SIERRA ESTATES SUBDIVISION, PHASE I

APPLICATION NUMBER 10 DATE January 7, 2016

REQUEST Subdivision

DETAIL SITE PLAN

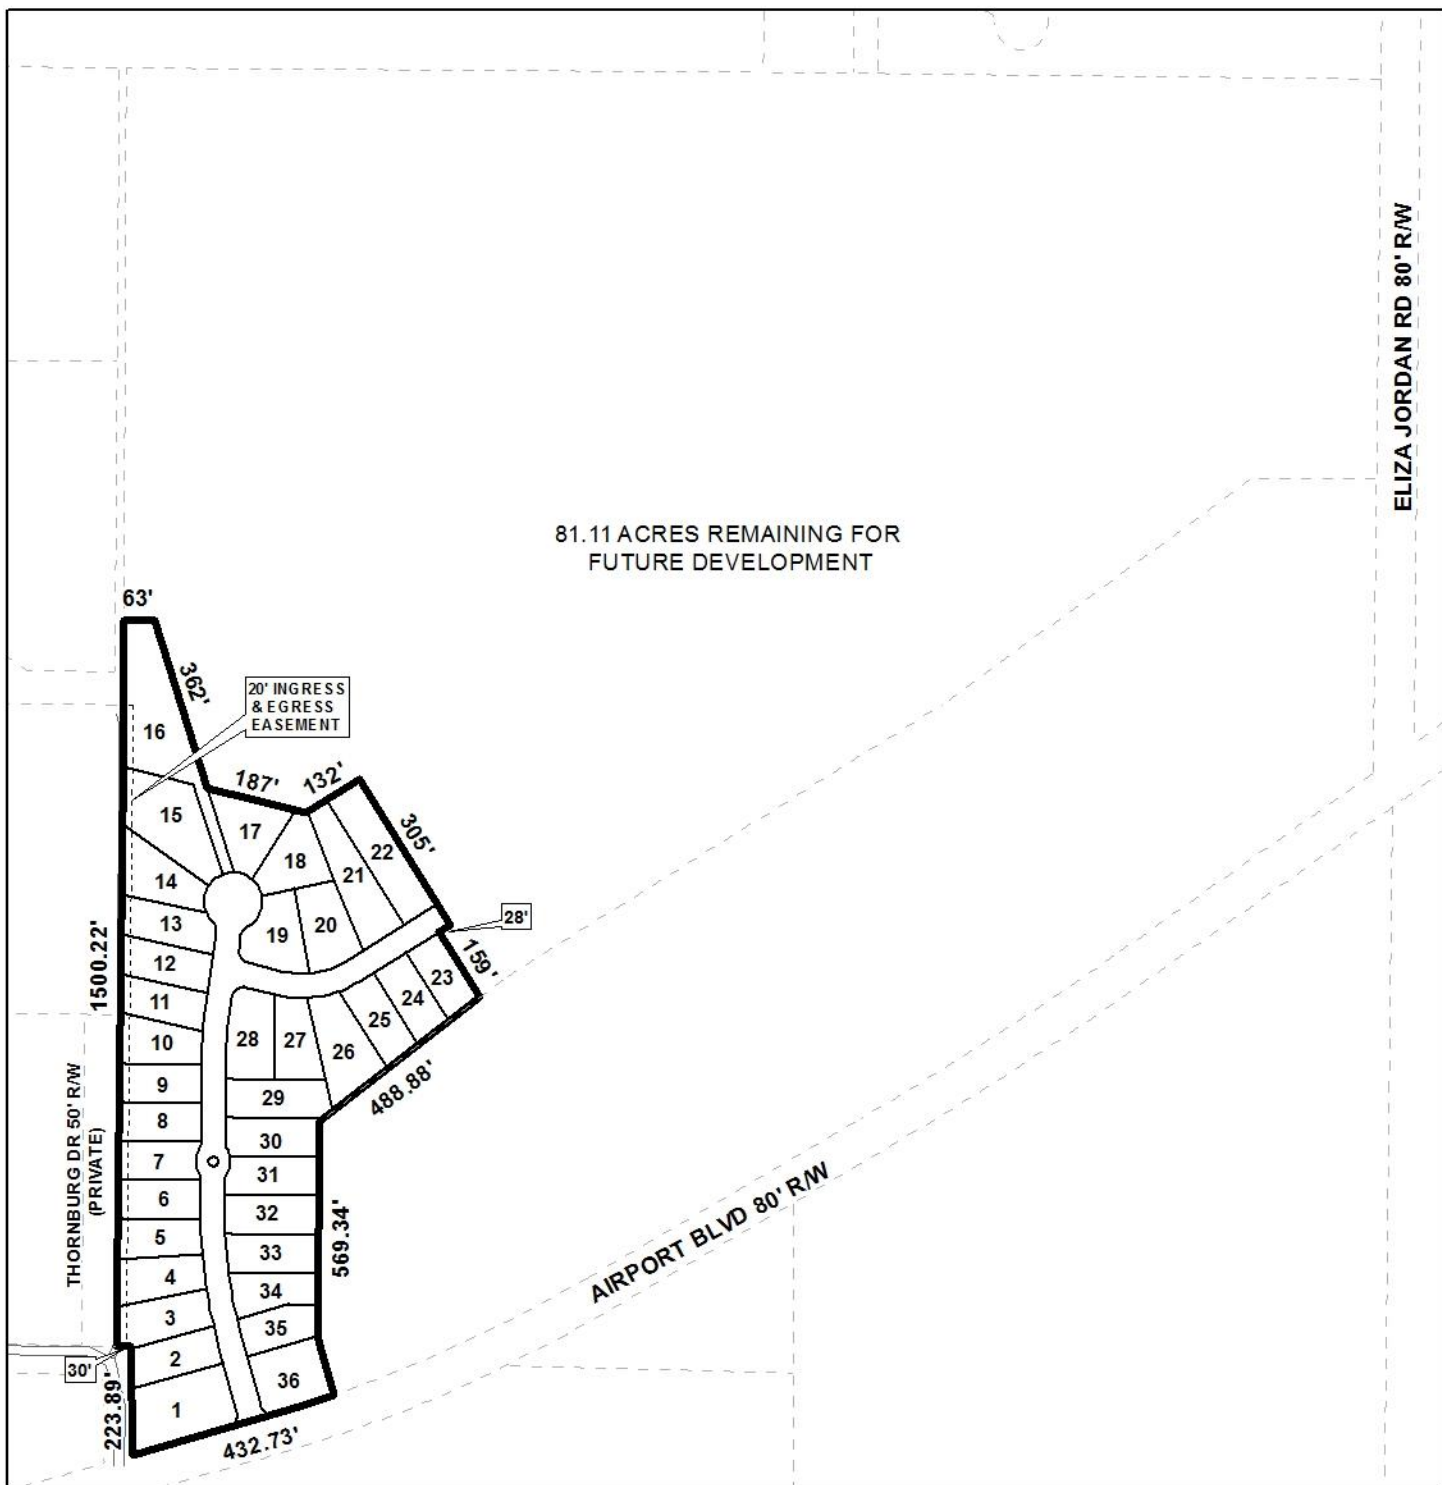
No lot areas are indicated on the preliminary plat. The plat should be revised to label each lot with its size in both square feet and acres, or a table should be furnished on the Final Plat providing the same information. The size of Lots 1 and 36 should be indicated after any required frontage dedication along Airport Boulevard.

Section V.D.3. of the Subdivision Regulations states that the depth of lots shall not be more than 3.5 times the width of the lot at the building setback line. Lots 15, 16 and 22 exceed the allowable ratio, but are the same as presented with the previously approved Master Plan. Therefore, a waiver of this section would be in order.

The site has closed-end streets that exceed 600 feet. Thus, a waiver of Section V.B.6 of the Subdivision Regulations would be required. The plat indicates a compliant turnaround right-of-way diameter of 120 feet for the North-South street, but no turnaround is indicated for the street stub to the East. Therefore, the plat should be revised to provide a temporary turnaround on the street stub to the Future Development area. There is only one access point for all lots. Appendix D of the IFC, requires two points of access for single-family subdivisions with 30 or more lots. Therefore, the applicant should obtain written approval from the State Fire Marshall to allow one point of access for the Subdivision prior to signing the Final Plat.

The site has property lines at an intersection corner. Section V.D.6. of the Subdivision Regulations requires that *"property lines at street intersection corners shall be arcs having radii of at least 10 feet or shall be chords of such arcs."* The plat should be revised to label the curb radii onto Airport Boulevard meeting this requirement.

- 7) revision of the plat to label each lot with its size in both square feet and acres, or the furnishing of a table on the Final Plat providing the same information;

- 11) the provision of a County Letter of Acceptance for new street construction within the Subdivision prior to signing the Final Plat;
- 12) revision of the plat to provide a temporary turnaround on the street stub to the Future Development area;

- 14) revision of the plat to indicate street intersection curb radii in compliance with Section V.D.6. of the Subdivision Regulations along Airport Boulevard;
